**ADDENDUM NO. 3**

IRONDALE FIRE STATION No. 3

THIS ADDENDUM FORMS A PART OF THE CONTRACT DOCUMENTS. THE FOLLOWING CONDITIONS TAKE PRECEDENCE OVER ANY CONFLICTING CONDITIONS IN THE DRAWINGS AND SPECIFICATIONS. THE DRAWINGS AND SPECIFICATIONS ARE HEREBY AMENDED IN THE FOLLOWING PARTICULARS.

SHEET NUMBER  
**P3.1**

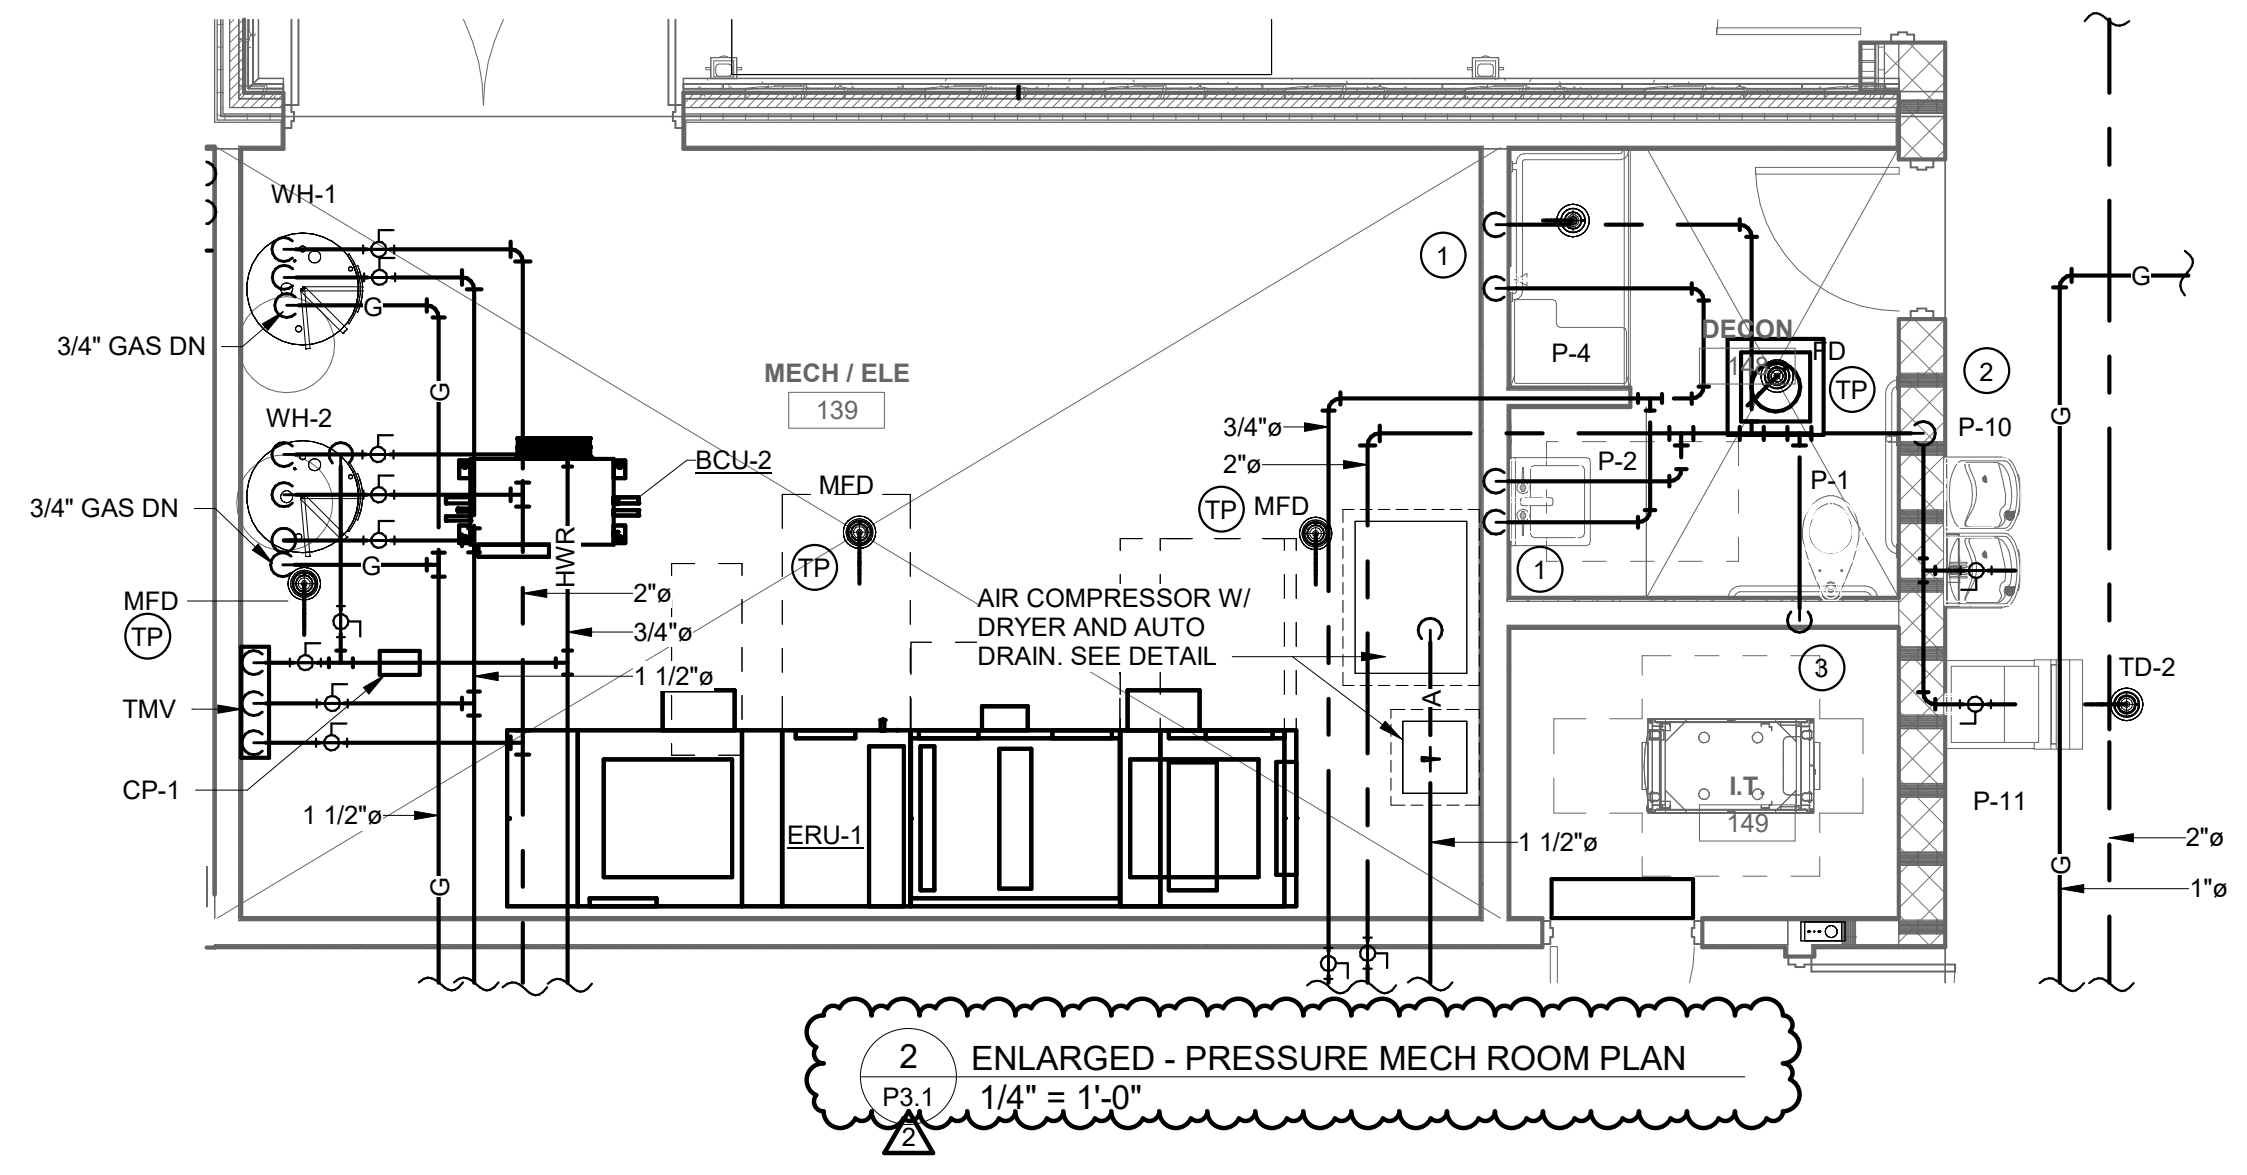
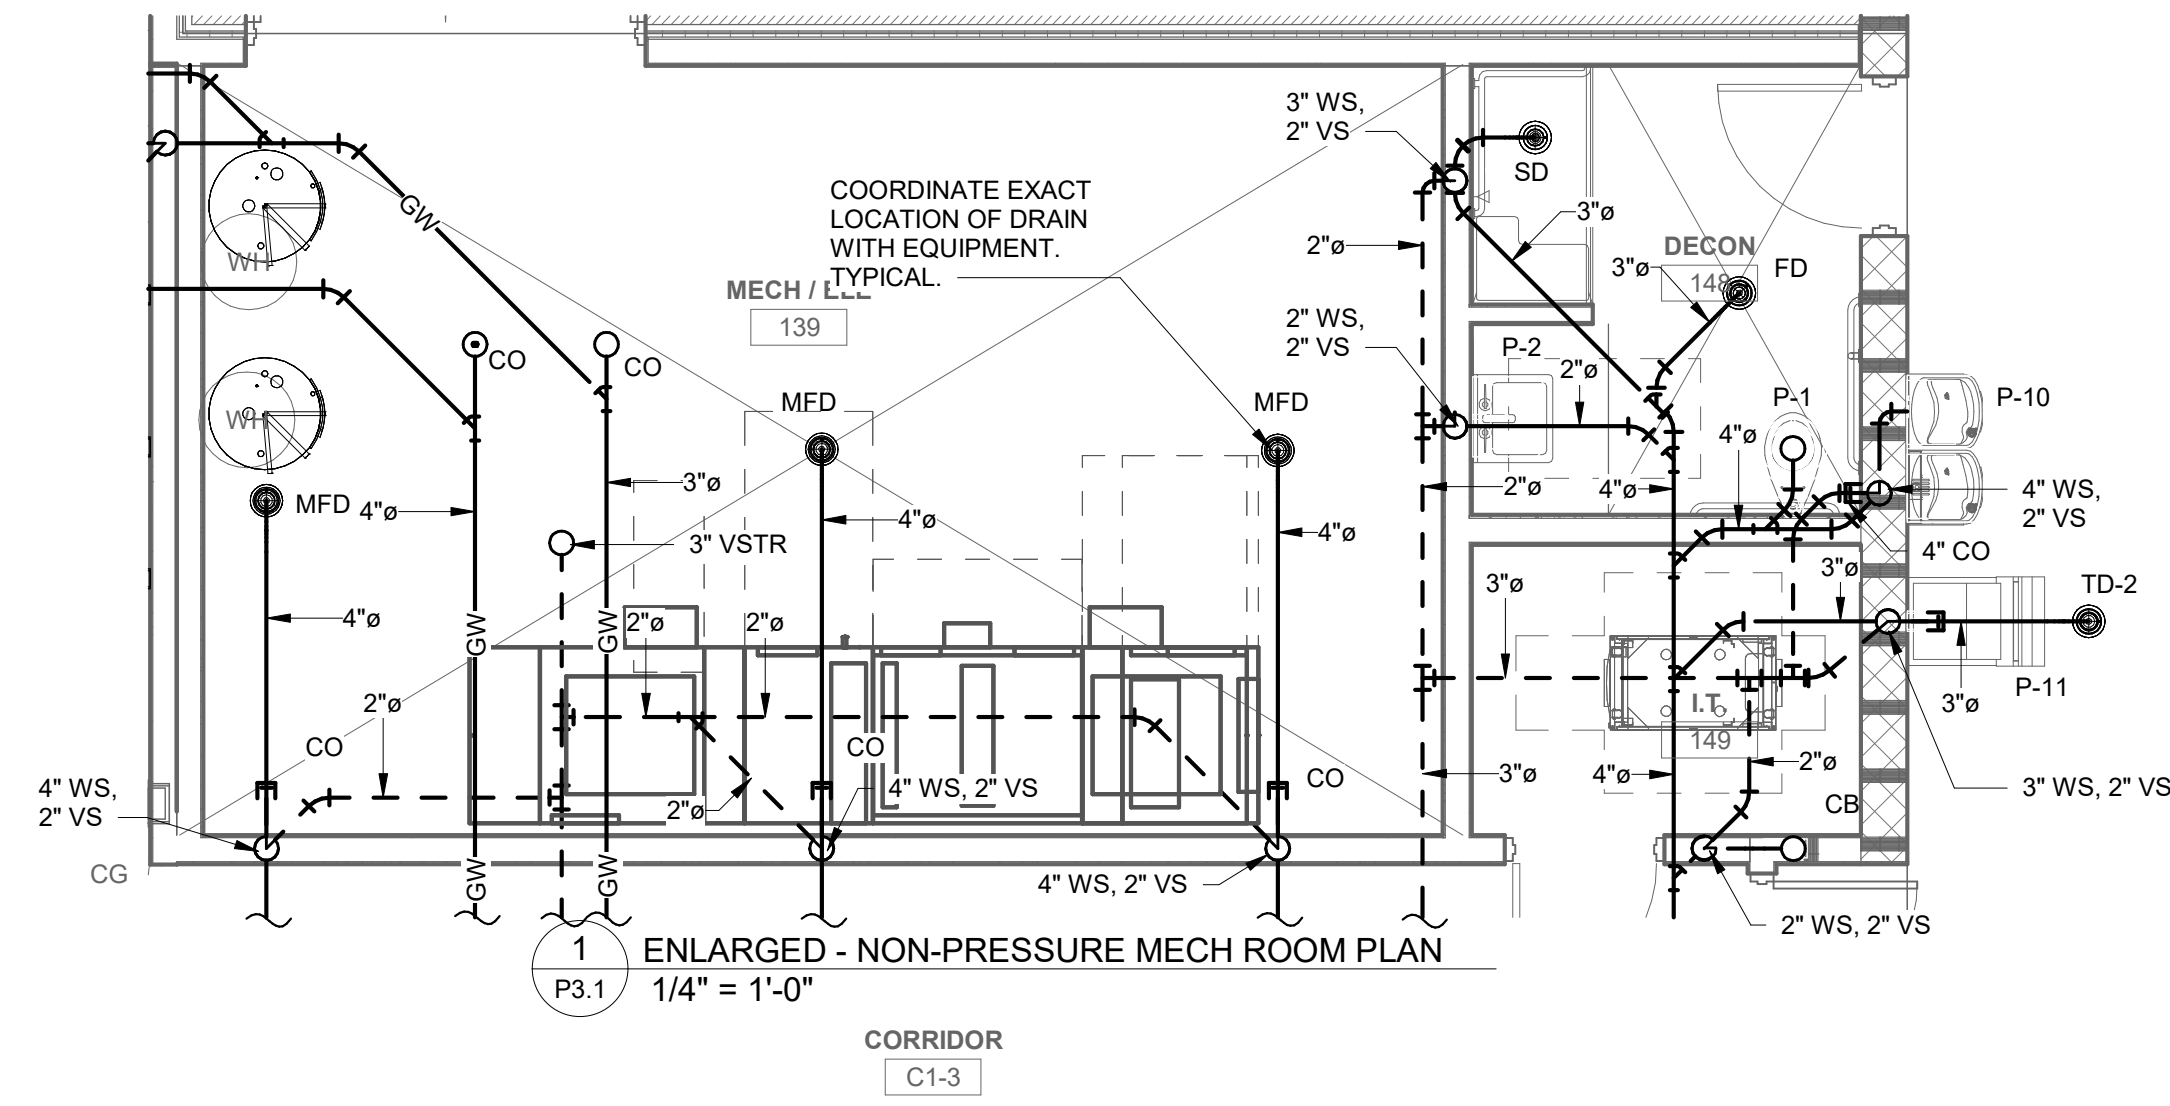
24. P2.1 Pressure Piping – Floor Plan: changes related to switching to gas hot water heaters
25. P3.1 Plumbing – Enlarged Plans: Edited layout in Pressure Mech Room Plan

Level 1 Plan - Lighting  
 1/8" = 1'-0"

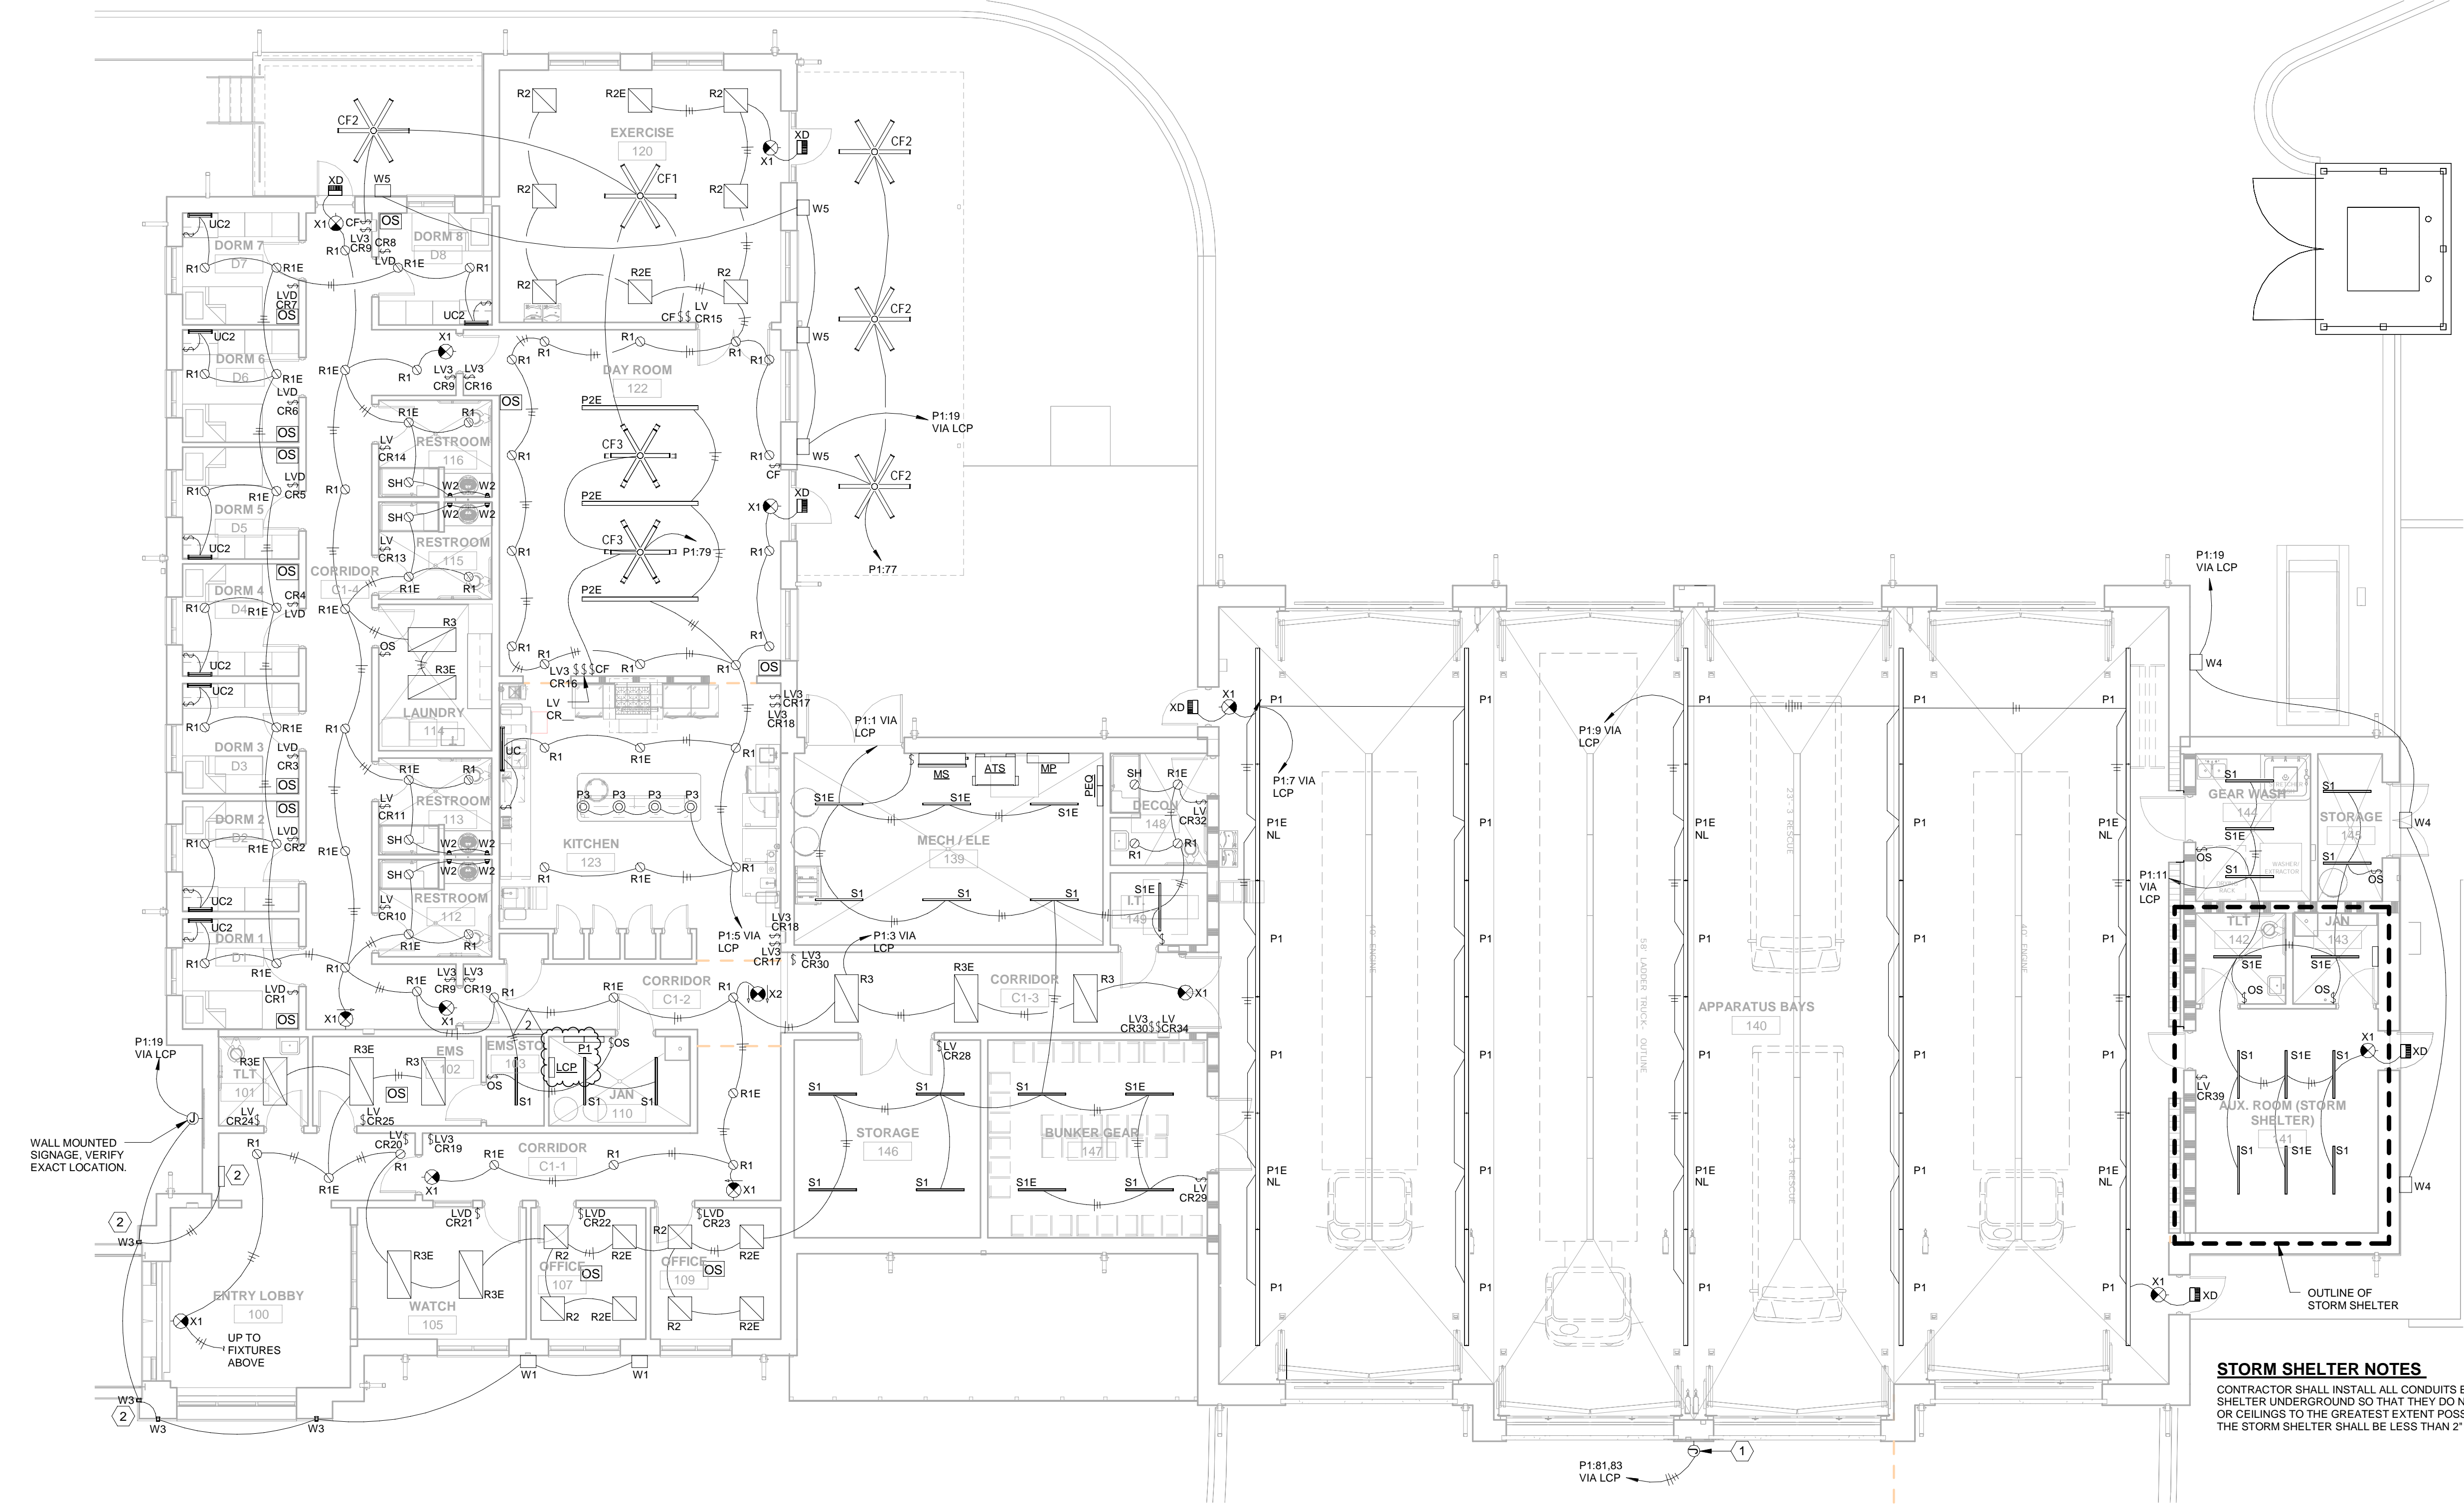
26. E002 Lighting Fixture Schedule and Details: Changed fixture tag 'UC' to UC2'.
27. E201 Level 1 Plan Lighting:
  - a. Moved Panel 'P1' into Janitor Closet #110.

- b. Added location for LCP Panel.
28. E202 Level 1 Plan Power:
  - a. Moved Panel 'P1' into Janitor Closet #110.
  - b. Added location for LCP Panel.
29. E203 Level 1 Plan Auxiliary:

11. *In sheet E201 - Lighting Plan shows that MECH / ELE Room is controlled by LCP but also is controlled by a single pole switch, please confirm which control is the correct.*

Answer: This room shall be controlled with an on-off switch only. Do not run lights in this room through the LCP.
